City of Ketchum Planning & Building

PROJECT:	P21-002
APPLICATION:	P21-002
OWNER:	Brennan Holdings No 300 LLC (Bob Brennan)
APPLICANT:	Brennan Holdings No 300 LLC (Bob Brennan)
REPRESENTATIVE:	Kurt Eggers, Eggers Associates
LOCATION:	1803 Warm Springs Road (Block 1, Warm Springs Ranch PUD) Block 2, Warm Springs Ranch PUD
ZONING:	General Residential – Low Density (GR-L), Tourist (T), Recreational Use (RU) and Floodplain Management Overlay (FP), Waterways and Floodway subdistricts
REQUEST:	Riparian restoration, fill in the floodplain related to subdivision development

Warm Springs Ranch Floodplain)	KETCHUM PLANNING AND ZONING
Development Permit and Waterways Design Review)	COMMISSION FINDINGS OF FACT,
Date: April 27, 2021)	CONCLUSIONS OF LAW, AND DECISION
File No: P21-002)

L2 - Block 1 - Riparian Restoration Plan

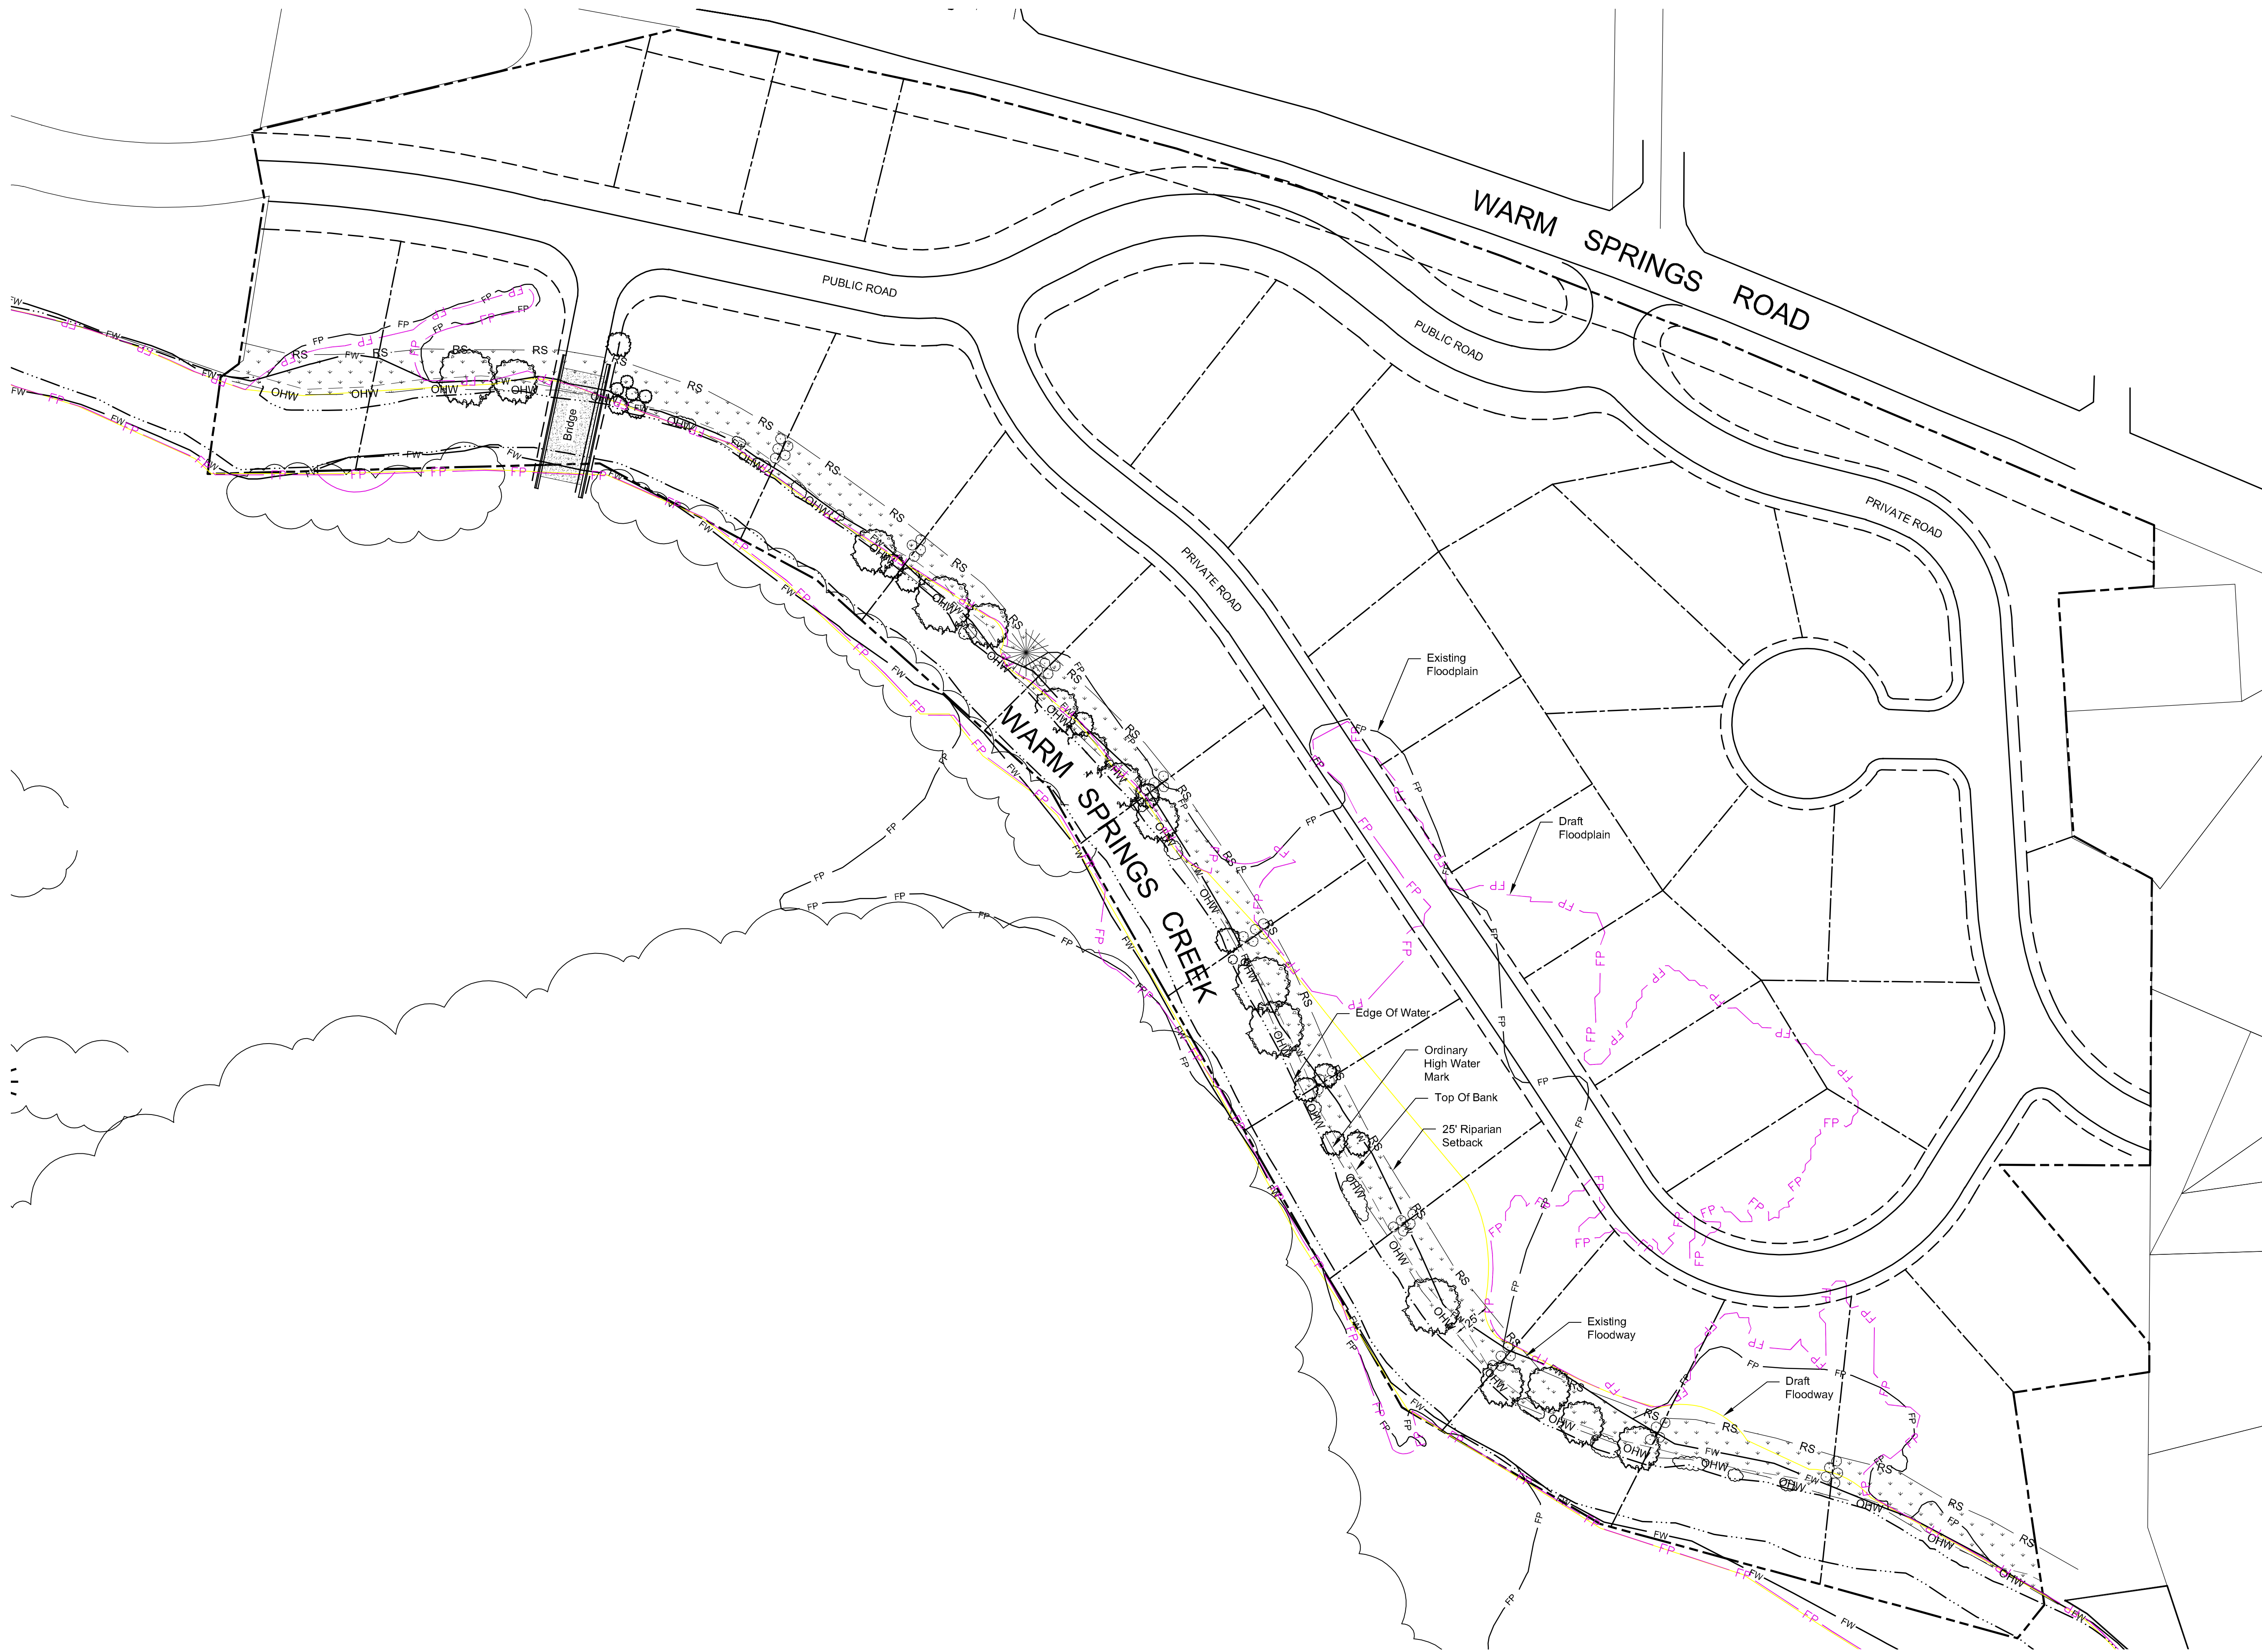
The riparian restoration plan, Sheet L2 and the detailed plans for each of the 13 lots, (Attachment C), include the planting of 70 new 5-gallon size native shrubs (three species of willows, common snowberry, red-osier dogwood, and golden currant) and a native grass mix during the summer of 2021, the installation of temporary irrigation (for a maximum of two growing seasons) to aid in the vegetation's establishment, weed control (hand-pulling, no topical application of weed sprays are proposed), monitoring and re-planting over the initial two-year establishment period, and retention of existing riparian vegetation. And as noted before, both the proposed subdivision plat and the Development Agreement include language dedicating the riparian zone as an easement across the private lots that will be governed and managed by the HOA, altered only with the appropriate city permits. Plat note 20. states in full:

The restoration plan associated with this application serves as the overall plan, until such time in the future a modification may be put forward. Staff is recommending approval of the proposed riparian restoration plan.

L2.2 - Block 1 - Building Envelopes

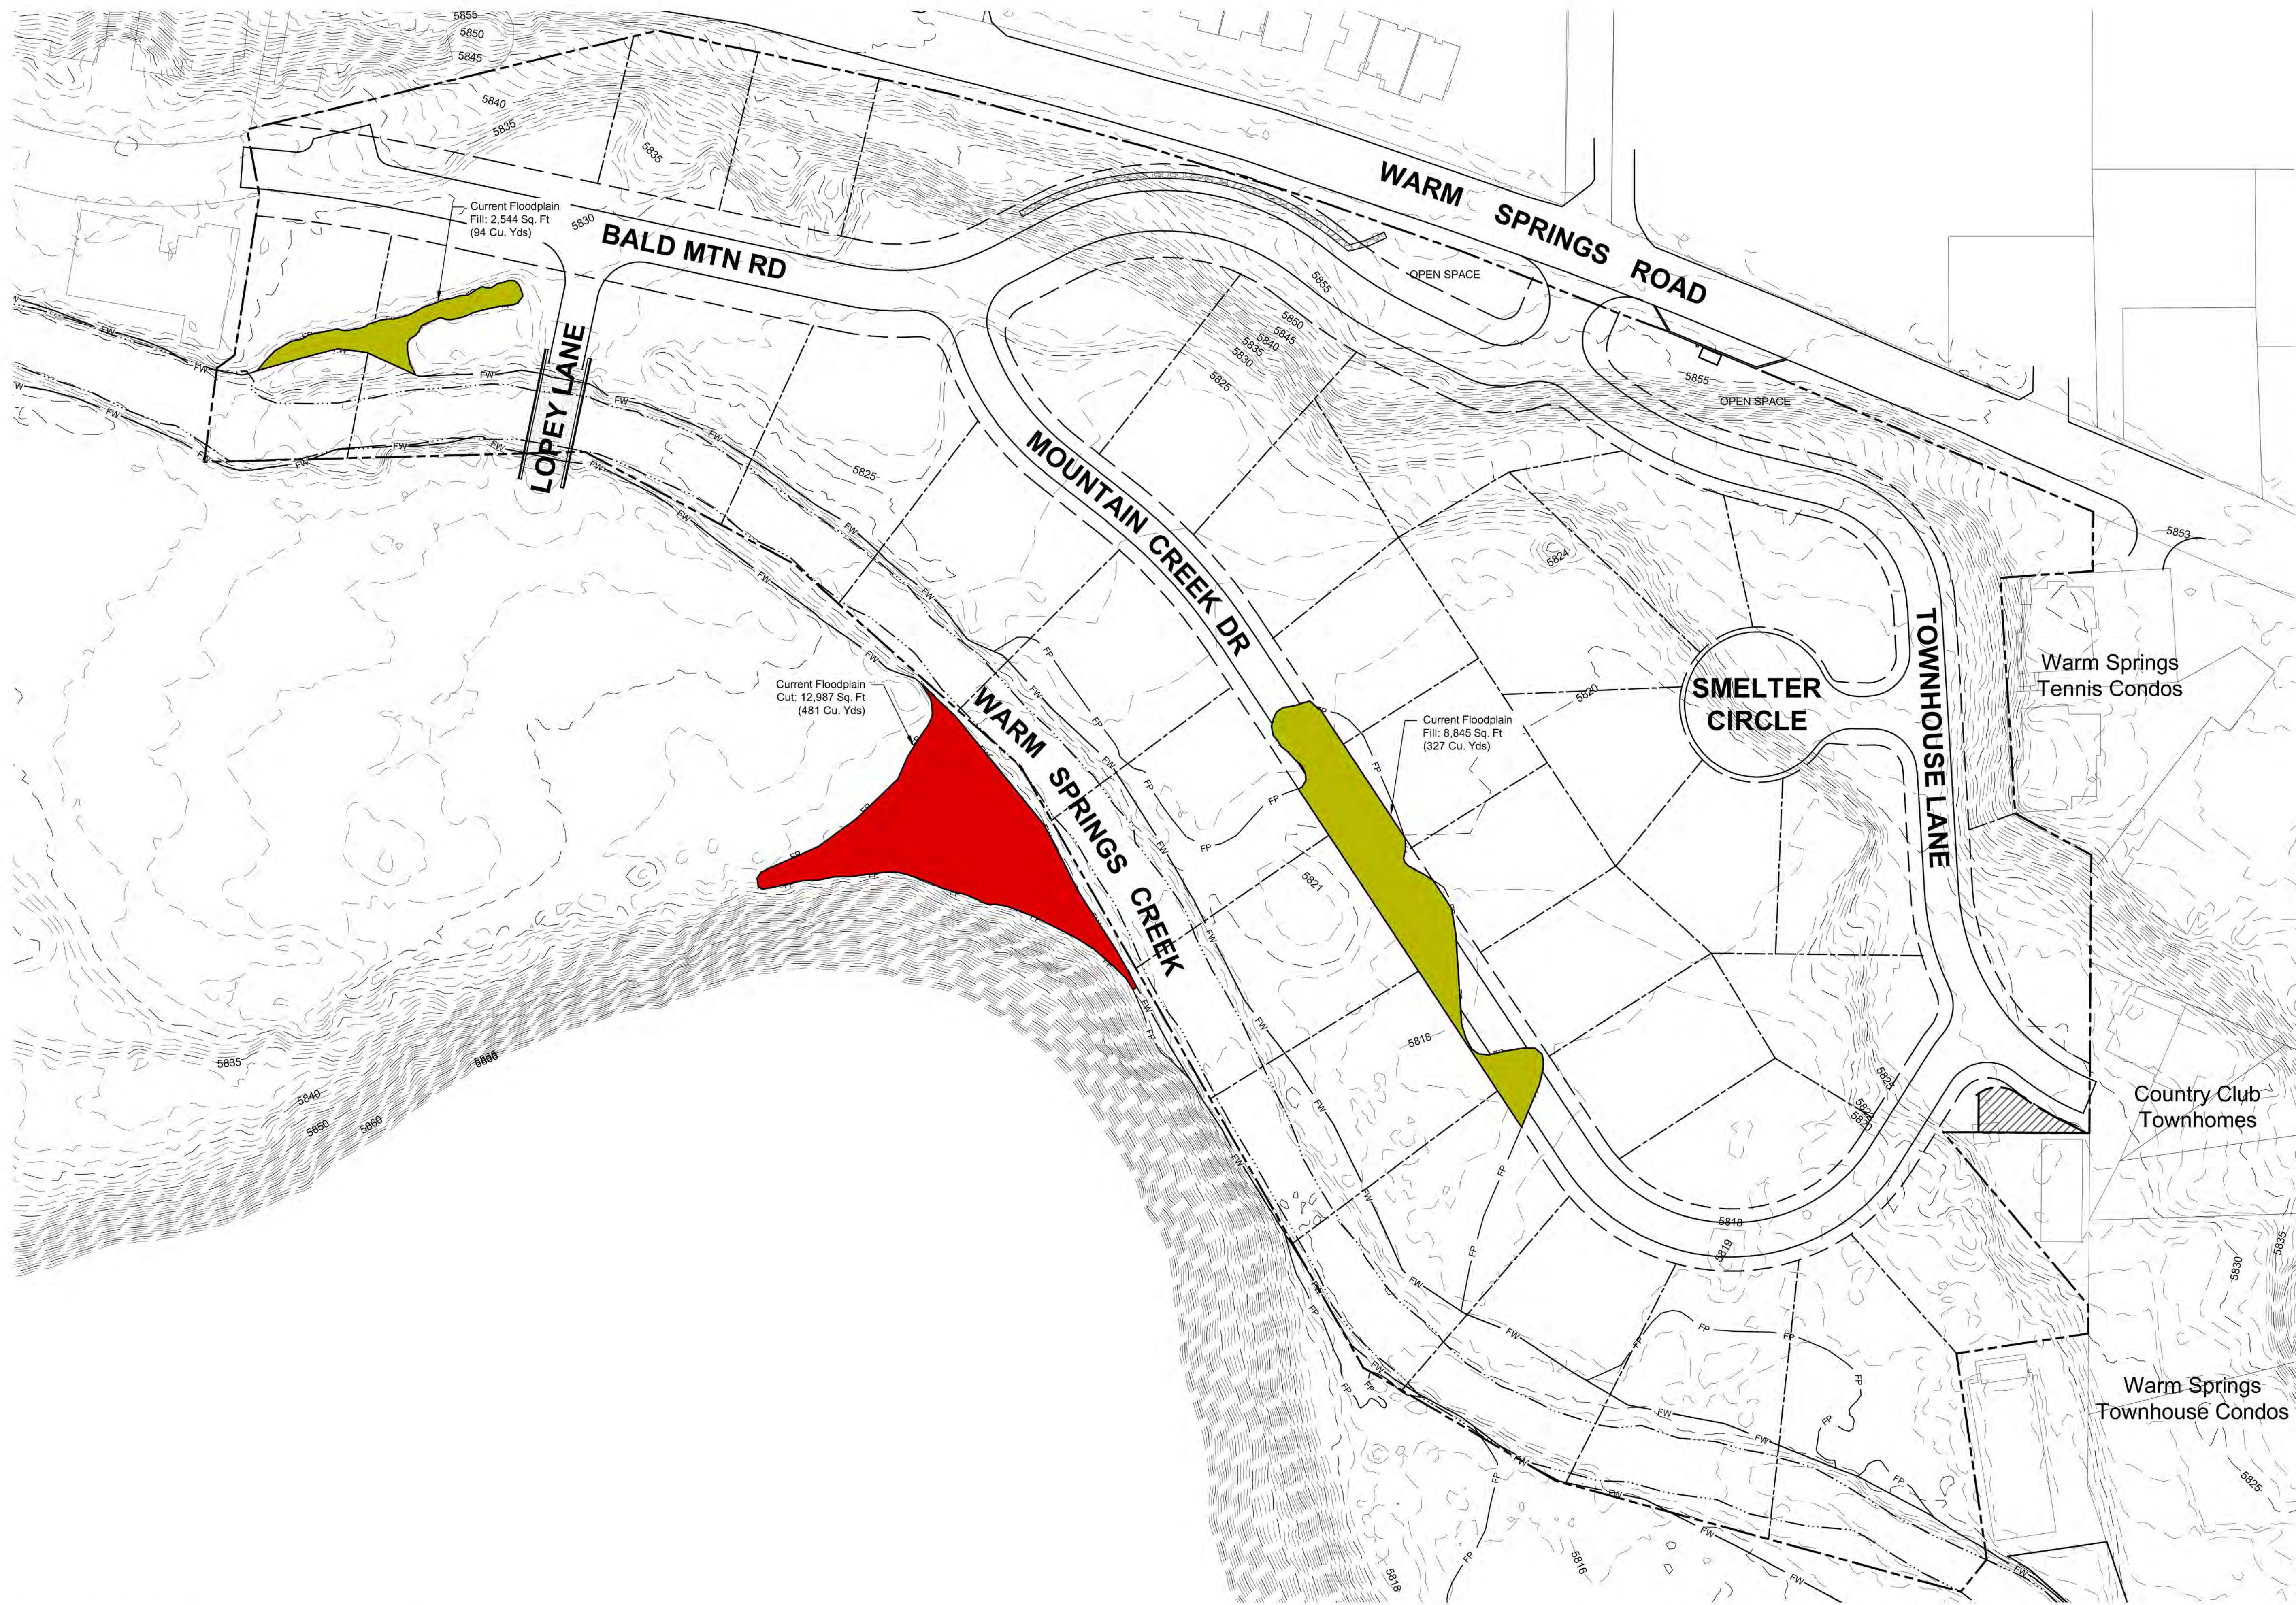
Jen Zung's analysis, the building envelopes for lots 8, 9, 10, 11 and 12 would encroach into the future floodway should FEMA adopt the new floodplain boundaries. In Ketchum, structures are prohibited in the floodway. Because the revised maps are not yet adopted, and the ability to require modifications based on draft maps is problematic, staff is recommending a condition of approval to this permit that states:

4. The City of Ketchum municipal code Chapter 17.88.040. C.1. states that “new residential structures and residential substantial improvements are prohibited in the floodway.” Plan sheet L2.2. – Block 1 – Building Envelopes shows building envelopes for lots 8, 9, 10, 11, and 12 that encroach into the draft floodway. As stated above and reiterated by FEMA in a March 4, 2021 email, the City can, and should, require the more conservative data be used as the basis for any permits. Thus, I would recommend that the plat be amended so that there are no building envelopes located in either the effective or preliminary floodway.

"This approval does not authorize or grandfather the placement of any structure or improvement within the floodway based on the 2010 Flood Insurance Rate Maps prepared by FEMA and any subsequent changes or amendments to the maps as adopted by the City of Ketchum."

With this condition, in the event the FEMA maps change and the floodway boundaries impact lots 8-12, if no permit for development has been issued on those lots, any future improvements would be prohibited within the floodway.

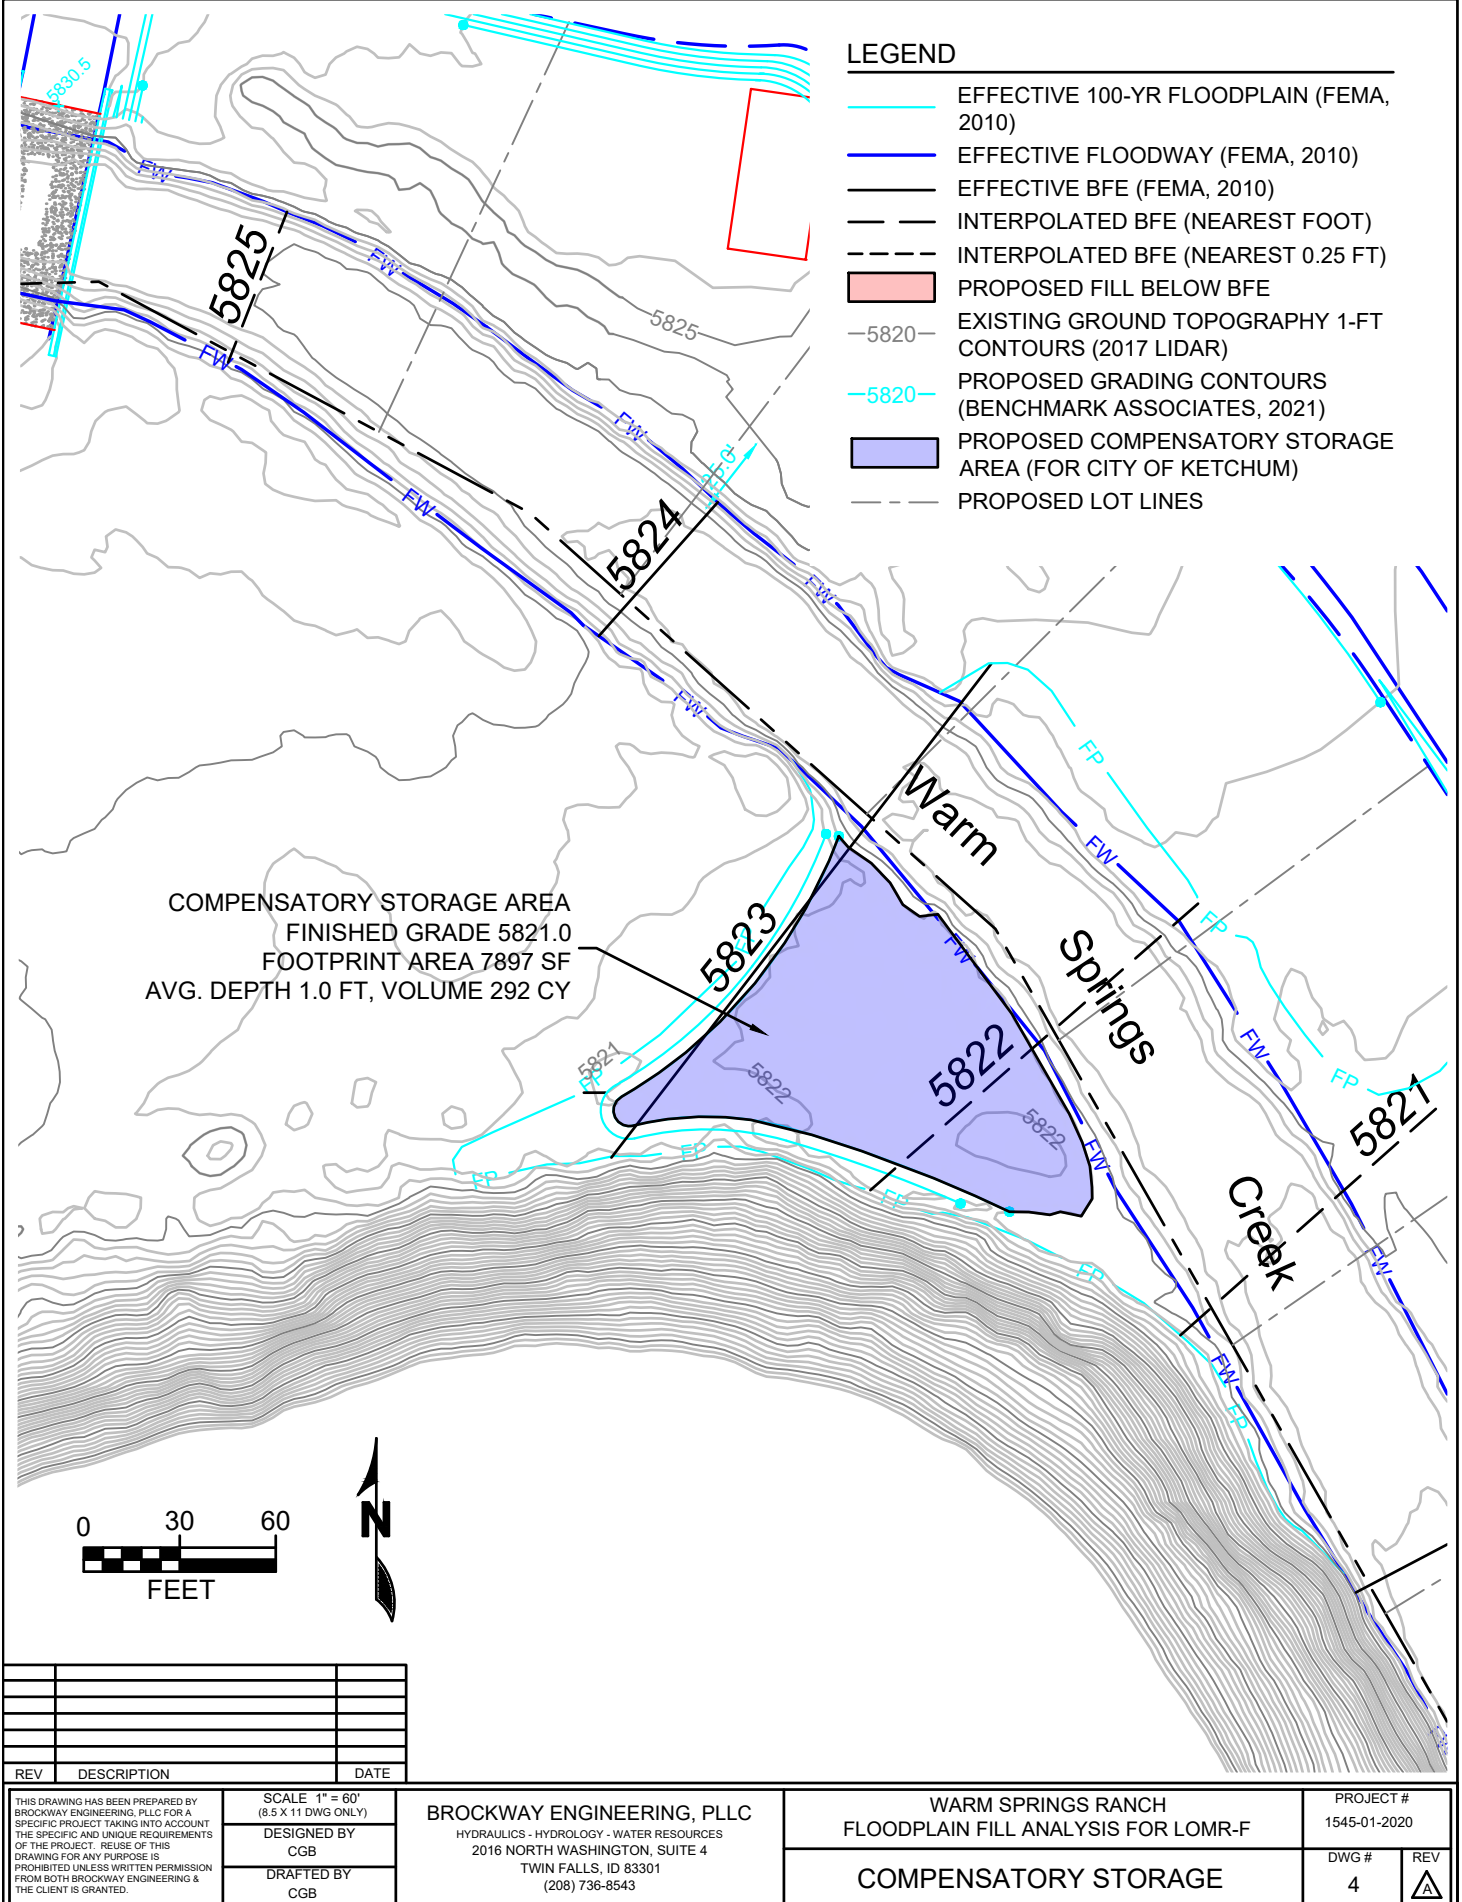
3. The compensatory storage proposed is located at preliminary cross section E, which has a BFE of 5821.50'. The proposed storage is between elevations 5821' and 5822'. However, only the amount of storage located below the BFE will be activated. Please verify that adequate compensatory storage is being provided that is located below both the preliminary and effective BFEs.
